**AMENDMENTS TO THE DRAWINGS**

Appl. No. 10/628,820  
Amtd. Dated 26 Dec. 2004  
Reply To Office Action 29 Sept. 2004  
Annotated Sheet Showing Changes

Figure\_1

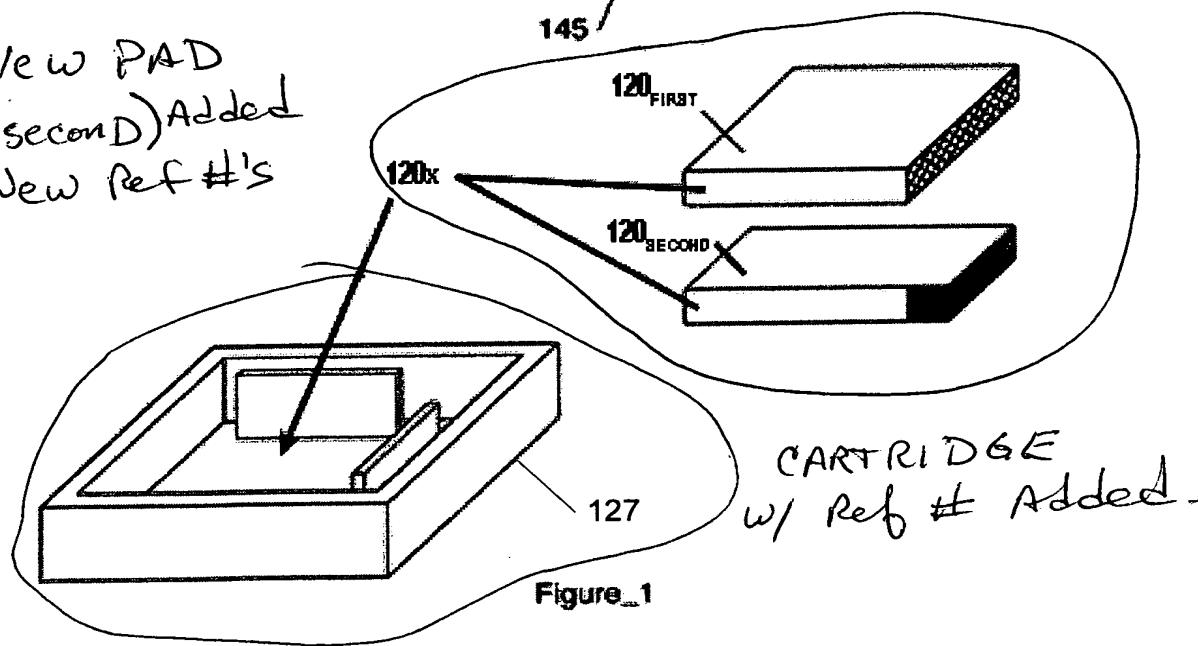
The disclosed adapter/cartridge was added and a reference (127) was also added.

The pad 120 originally depicted in Figure 1 has been replaced by a depiction of two-different pads as described in the specification. A first type (120<sub>FIRST</sub>) having adhesive along one side along one peripheral edge and a second type (120<sub>SECOND</sub>) having adhesive layered between successive pad elements. Additionally, these two pad types are shown having different peripheral dimensions as disclosed in the

specification. References to the pad numbers have been added, as well as an indication of the placement of either pad with respect to cartridge 127.

New PAD  
(120 second) Added  
& New Ref #'s

Appl. No. 10/628,820  
Amdt. Dated 26 Dec. 2004  
Reply To Office Action 29 Sept. 2004  
Annotated Sheet Showing Changes

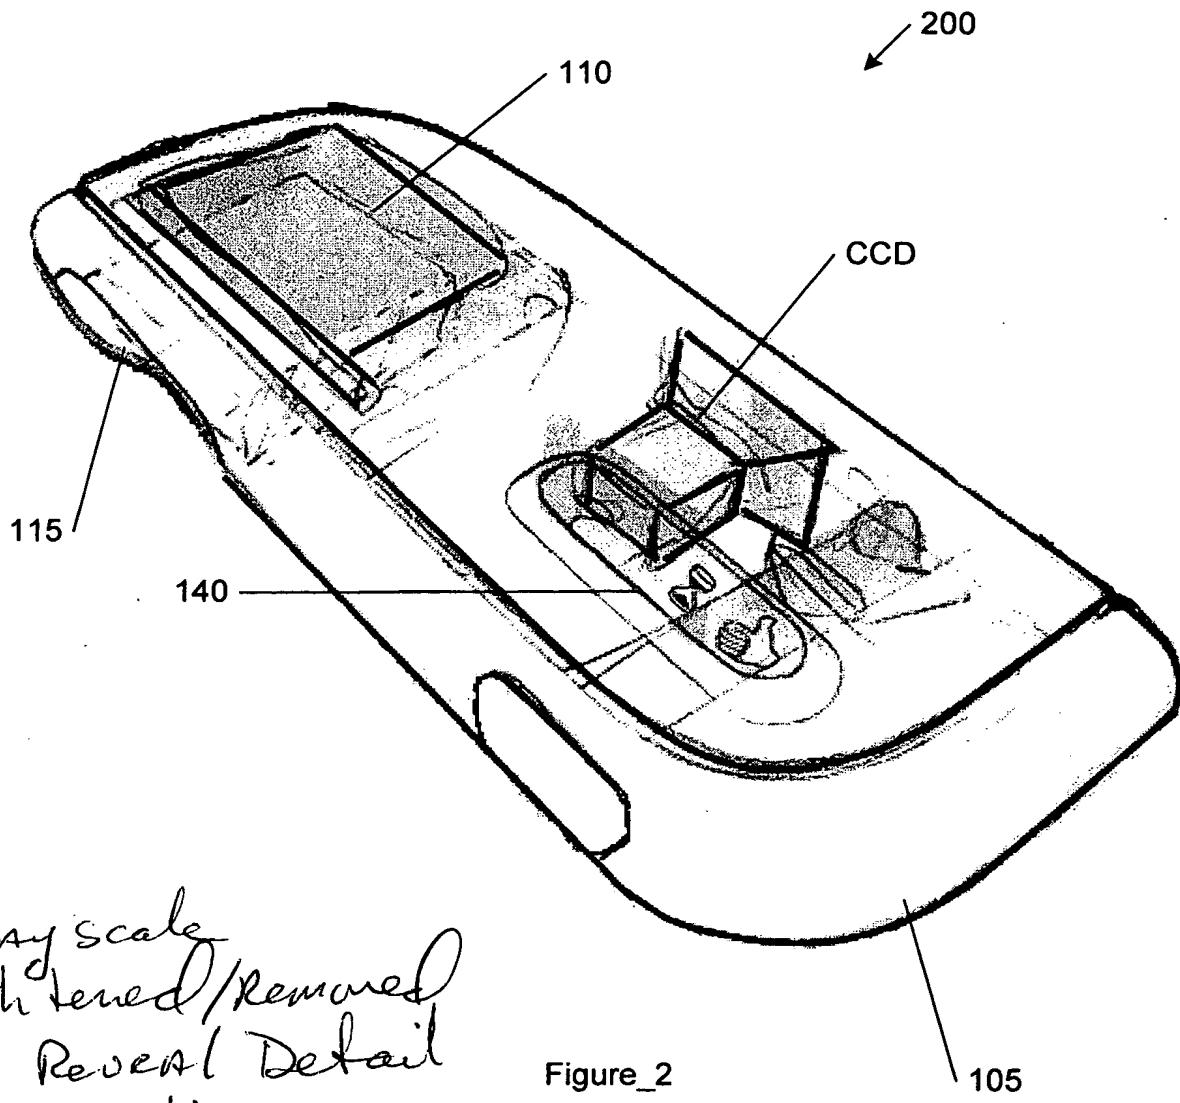
The Office Action asserted that due to various reproductions and processing the Figure\_2 was too dark to allow many details to be clearly seen. The undersigned reprocessed these figures and removed much of the grayscale to permit more details to remain through the processings and reproductions.

Gray scale  
lightened/removed  
to reveal detail  
& some lines  
Added to sharpen  
existing features
